SUNDRY NOTICES AND REPORTS ON WELLS
Do not use this form for proposals to drill or to re-enter an abandoned well. Use Form 3160-3 (APD) for such proposals.

8. Well Name and No.
Rosa Unit #380

PLUG AND ABANDONMENT PROCEDURE

CONDITIONS OF APPROVAL

**ROSA UNIT #380- Proposed P&A
BASIN FRUITLAND COAL**

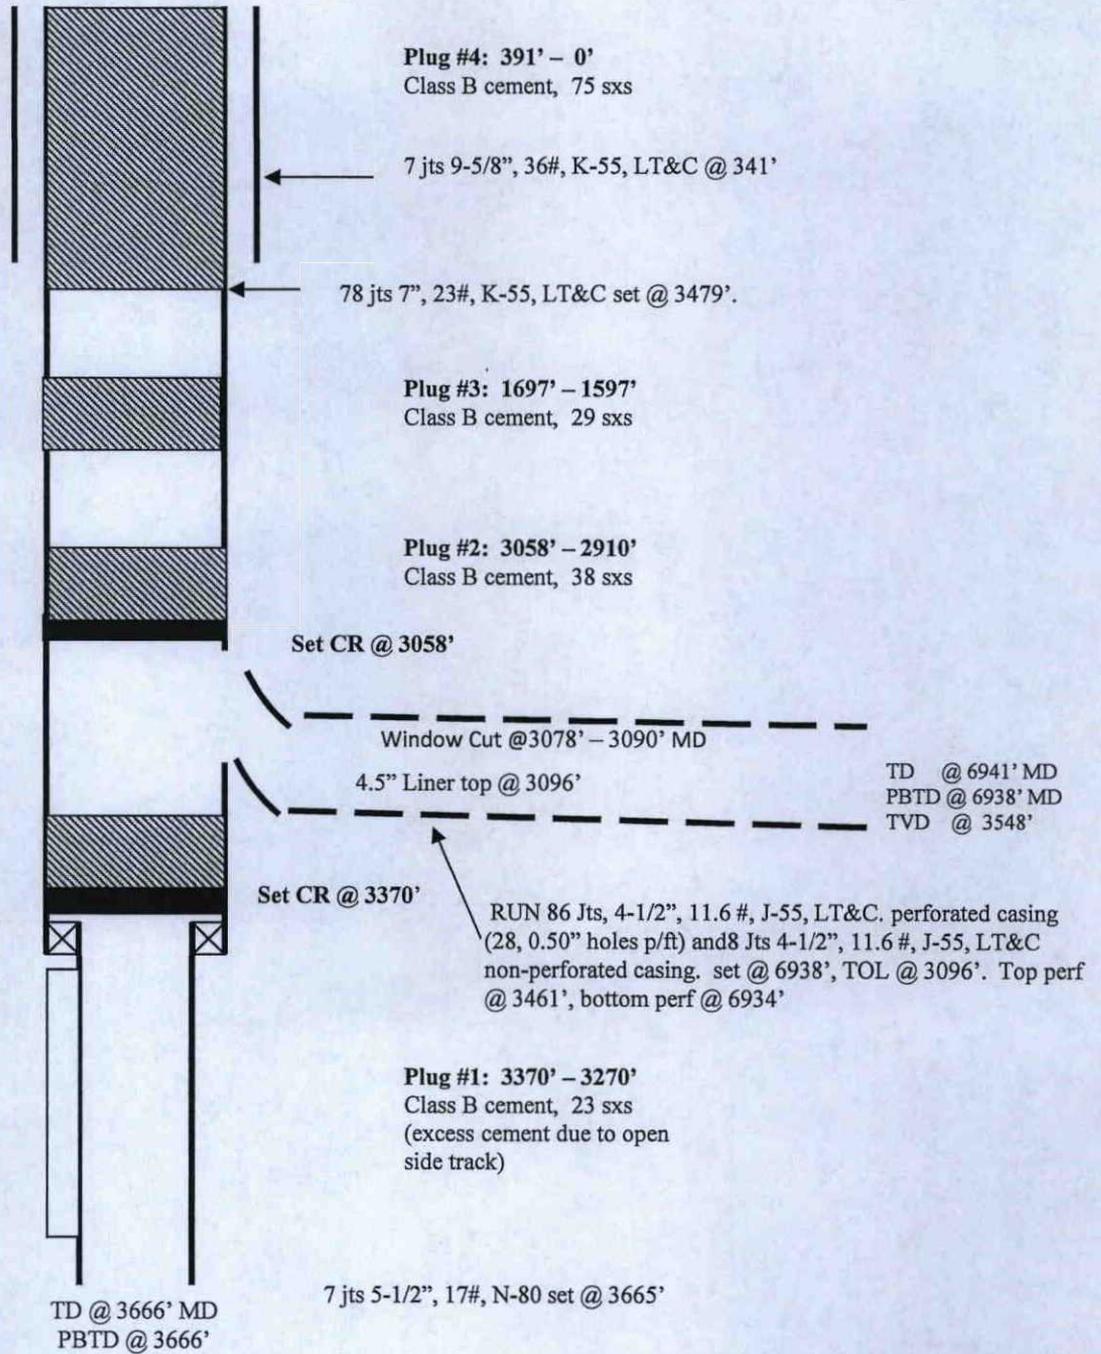
1. Plugging operations authorized are subject to the attached "General Requirements for Permanent Abandonment of Wells on Federal and Indian Lease."
2. Farmington Office is to be notified at least 24 hours before the plugging operations commence (505) 564-7750.
3. The following modifications to your plugging program are to be made:
 - a) Bring the top of plug #1 to 3219 ft. to cover the Fruitland top. BLM picks top of Fruitland at 3269 ft. Adjust cement volume accordingly.
 - b) Set plug #3 (1744-1644) ft. to cover the Nacimiento top. BLM picks top of Nacimiento at 1694 ft.
